UNITED STATES PATENT AND TRADEMARK OFFICE

10/800,727

Atsushi Hirota

DETAILED ACTION

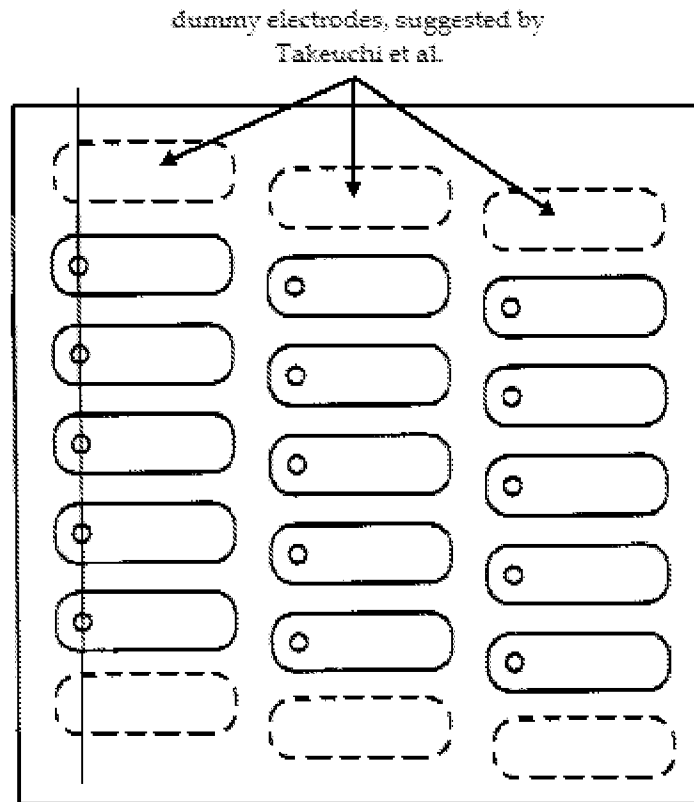
Therefore, at the time of invention, it would have been obvious to a person of ordinary skill in the art to modify Takahashi's actuator unit to include dummy electrodes spaced in an outward direction from the individual electrodes, such that one of the dummy electrodes is spaced from Takahashi's outermost individual electrode with respect to two arrangement directions of the plurality of individual electrodes (see Drawing A below).

Takahashi as modified by Takeuchi et al. discloses all the limitations of claims 1/15, and **the combination of Takahashi as modified by Takeuchi et al. also suggest** that each of the individual electrodes, other than the outermost one with respect to one of the two arrangement directions, is surrounded with corresponding ones of the individual electrodes arranged in a predetermined pattern (Drawing A); and

wherein the outermost one of the individual electrodes with respect to the two arrangement directions of the plurality of individual electrodes is surrounded with a corresponding one of the individual electrodes and a corresponding one of the dummy electrodes arranged in substantially the same pattern as the predetermined pattern (Drawing A).

the combination of Takahashi as modified by Takeuchi et al. also disclose that a plurality of the dummy electrodes are arranged adjacent to each other so as to surround the plurality of individual electrodes arranged adjacent to each other in a matrix (Drawing A).

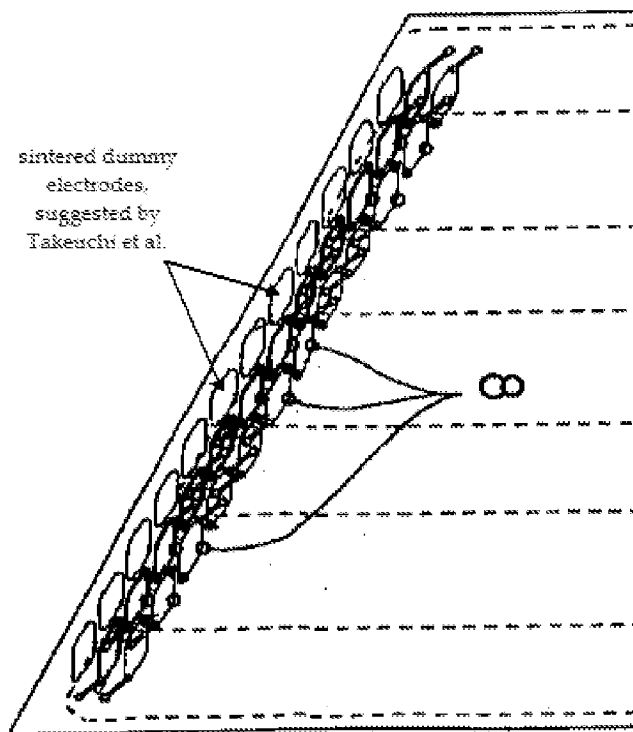
Therefore, at the time of invention, it would have been obvious to a person of ordinary skill in the art to modify Sakaida's actuator unit to include sintered dummy electrodes arranged adjacent to each other so as to surround the plurality of individual electrodes (Drawing B below).

Sakaida as modified by Takeuchi et al. discloses all the limitations of claim 21, and **Takeuchi et al. also suggest** that the sintered dummy electrodes are spaced from the outermost one of the individual electrodes with respect to two arrangement directions of the individual electrodes (Drawing B), and

wherein the two arrangement directions are formed in intersecting planes
(Drawing B).
